Project	IEEE 802.16 Broadband Wireless Access Working Group < http://ieee802.org/16 >	
Title	Comments on SDD Relay Station State Diagram	
Date Submitted	2009-07-06	
Source(s)	Yih-Guang Jan, Yang-Han Lee, Hsien-Wei Tseng, Ming-Hsueh Chuang, Jheng-Yao Lin Tamkang University (TKU)	yihjan@yahoo.com
	Youn-Tai Lee, Chun-Yen Hsu Institute for Information Industry (III)	lyt@nmi.iii.org.tw
	Shiann-Tsong Sheu National Central University (NCU)	stsheu@ce.ncu.edu.tw
	Whai-En Chen National Ilan University (NIU)	wechen@niu.edu.tw
Re:	"Comments on SDD 14.4.1 Relay Station State Diagram"	
Abstract	Comments on SDD Relay Station State Diagram	
Purpose	To be discussed and adopted by TGM for the 802.16m SDD.	
Notice	<i>This document does not represent the agreed views of the IEEE 802.16 Working Group or any of its subgroups. It represents only the views of the participants listed in the "Source(s)" field above. It is offered as a basis for discussion. It is not binding on the contributor(s), who reserve(s) the right to add, amend or withdraw material contained herein.</i>

Comments on SDD Relay Station State Diagram

Figure 64 Initialization State Transition Diagram of IEEE802.16m Relay

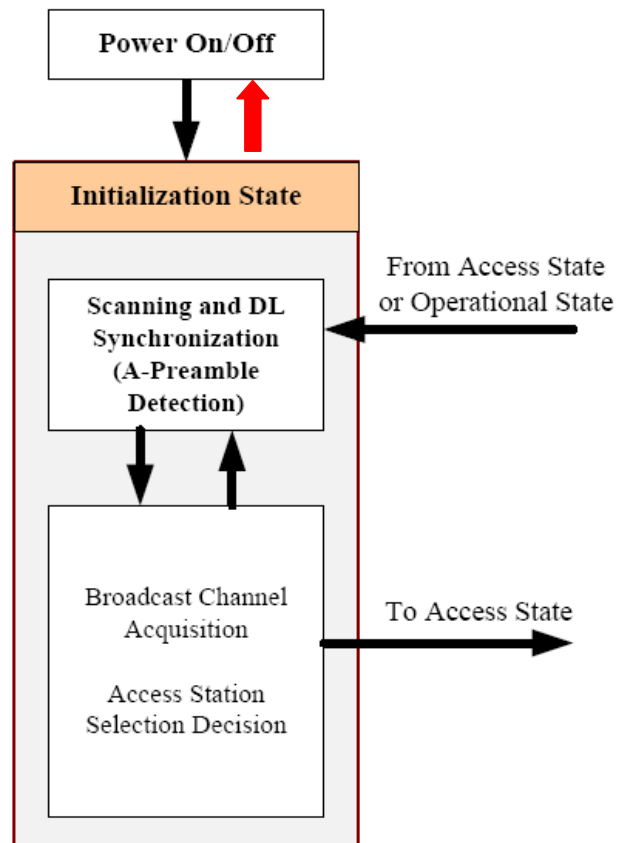
This contribution provides the corrected SDD text proposal to Pilot patterns. In Figure 64, it misses the signal flow from Initialization State to the Power On/Off state.

[In IEEE 80216m-08_003r9a, Section 14.4.1.1, insert in Figure 64 the signal flow from the Initialization State to the Power On/Off State.]
